## HL-LHC radiation level studies and specification document

# HL-LHC radiation level specification document

# EDMS 2302154 v1.1: updates

# EDMS comments since circulation on August 2<sup>nd</sup> (1)

# EDMS 2302154 v1.1: IR8 specifications

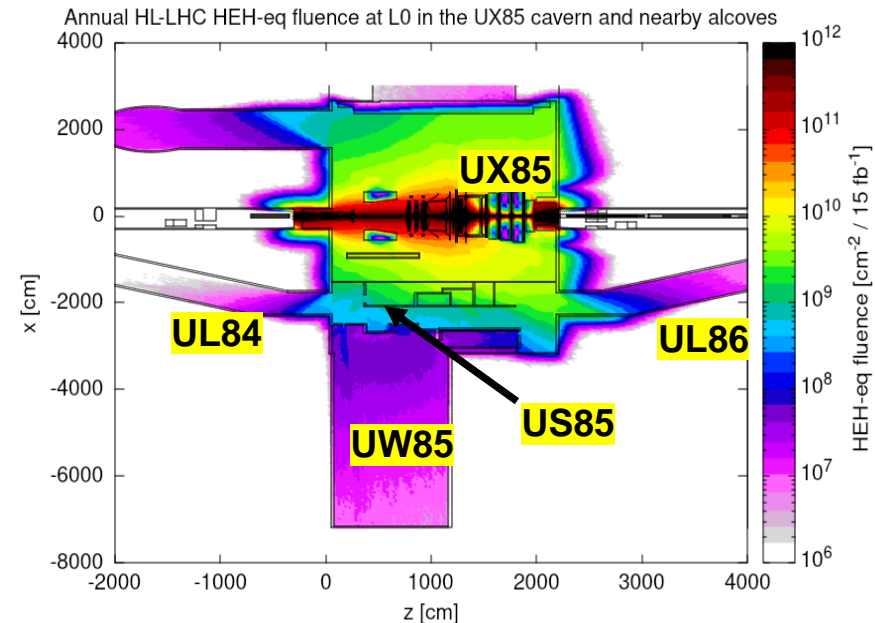
2.4.2	The specification here relies solely on FLUKA simulations. As stated, the radiation levels vary greatly over short distances. However, no margins are applied to the calculations. (Indeed, the conclusion later says “Safety margins are not explicitly included, but several conservative assumptions are made to mitigate the risk that the levels during regular HL-LHC operation will exceed the specifications.”) Apart from the luminosity, these assumptions are not described for IR8 alcoves. So what risks remain that levels could be higher than specified? (see comment below on table 2.27)  At what stage will actual measurements be available to validate the specifications?

The FLUKA model used to define the IR8 specifications has been benchmarked with the available RadMon measurements, and unlike the point-like RadMons, FLUKA allows to cover the full 3D geometry of the area. When FLUKA indicates that high radiation level gradients are present, the higher values within the areas of interest are used to set the specification, effectively providing a safety margin.

# EDMS 2302154 v1.1: IR4 BGC specifications

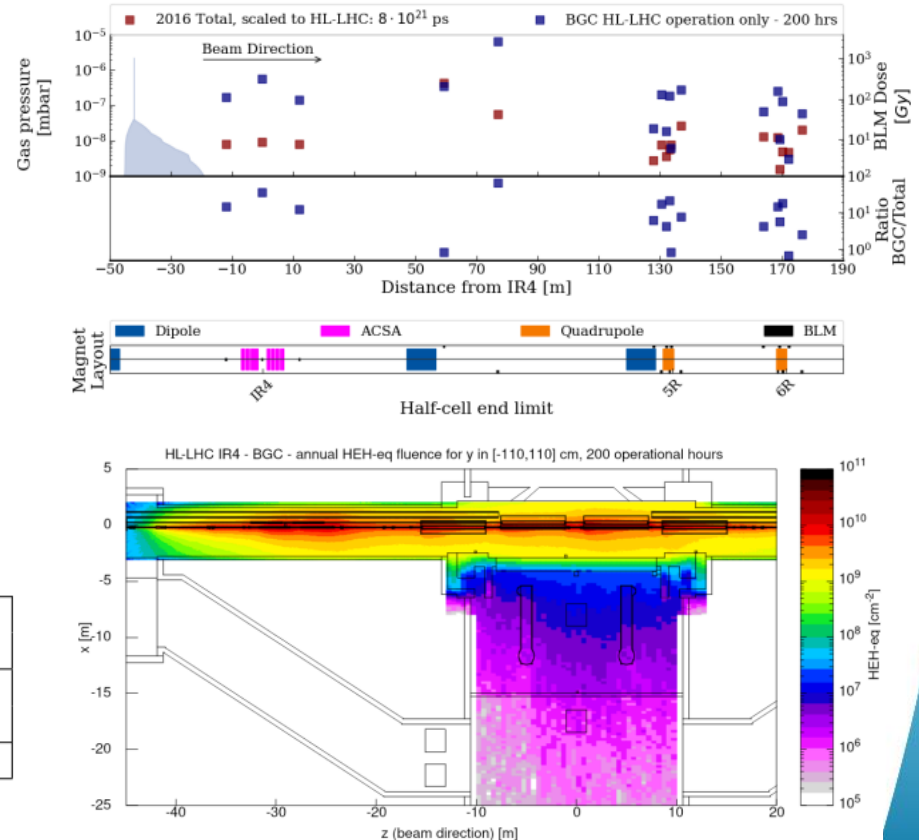
2.8	Here there is a good discussion of margins and because the specification is supported by measurement, one can perhaps have more confidence. Table 2.27 shows a significantly higher (scaled) measured level than predicted.

For US450 specifications, the rescaled 2016 data and the FLUKA simulation represent independent contributions to the radiation levels (i.e., non-BGC and BGC radiation). Note that also in this case, the FLUKA model is benchmarked with data from Run 3 BGC operation.
